**SITE CONTAMINATION WORK
PLAN**

**BERNARD'S GAS
1051 AIRWAY BOULEVARD
LIVERMORE, CALIFORNIA**

Grayland No. 120-010
January 18, 2002

DRAFTED BY: JAC	CHECKED BY: JAC	PROJECT NO. 120-010	SCALE: 1:480	GRAYLAND ENVIRONMENTAL
DWG DATE: 06-20-01	REV DATE: 01-14-02	BERNARD'S GAS	FIGURE 3	
MAP SOURCE: Site Visit Sketch		1051 AIRWAY BOULEVARD LIVERMORE, CALIFORNIA	PROPOSED SITE INVESTIGATION

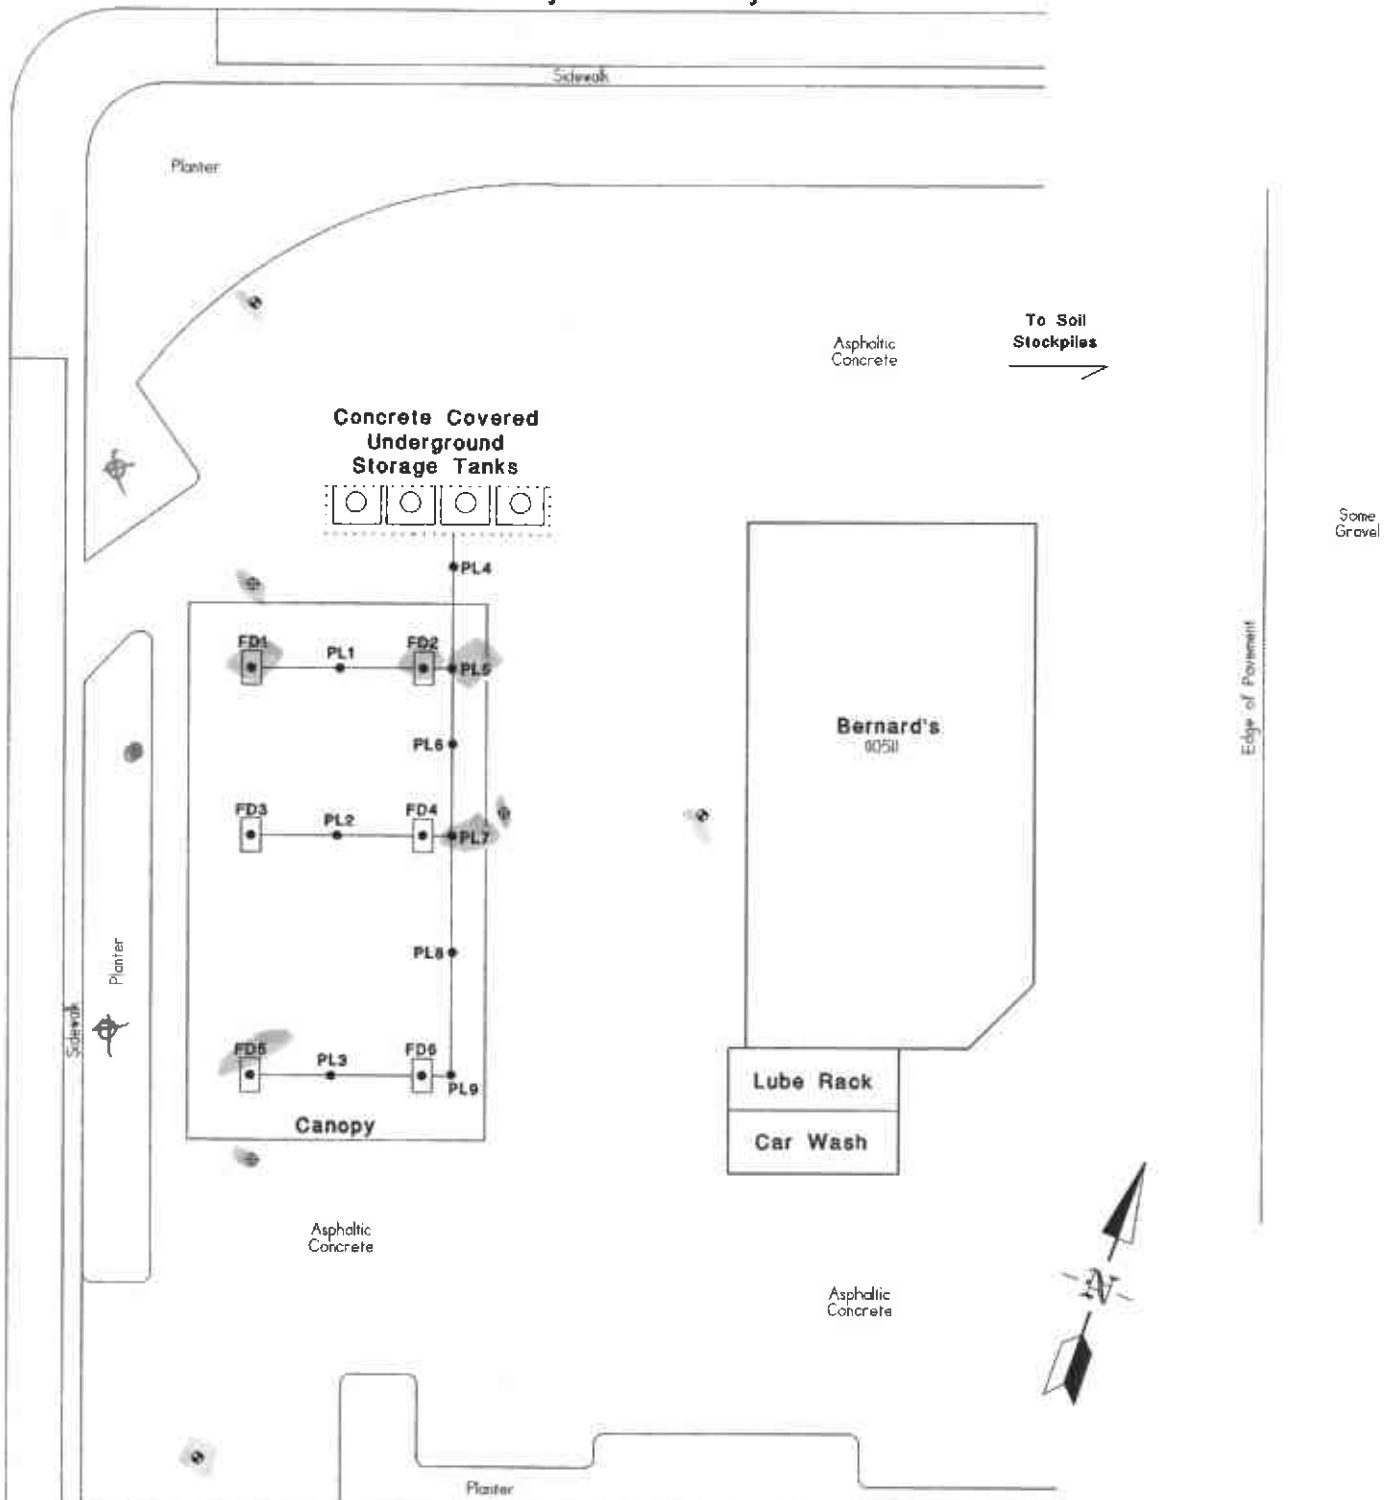
Water contours provided by Zone 7 suggest GW may flow
SSW. Therefore, would like proposed well

SSW of discharges and possible one that is NW and closer ~ 20' from
release

see recommended locations in red of
however location can be determined based on results from
soil borings + grab GW samples.

Also recommend another soil boring ~~west~~ WSW to distance FDI

delegated TAP detected
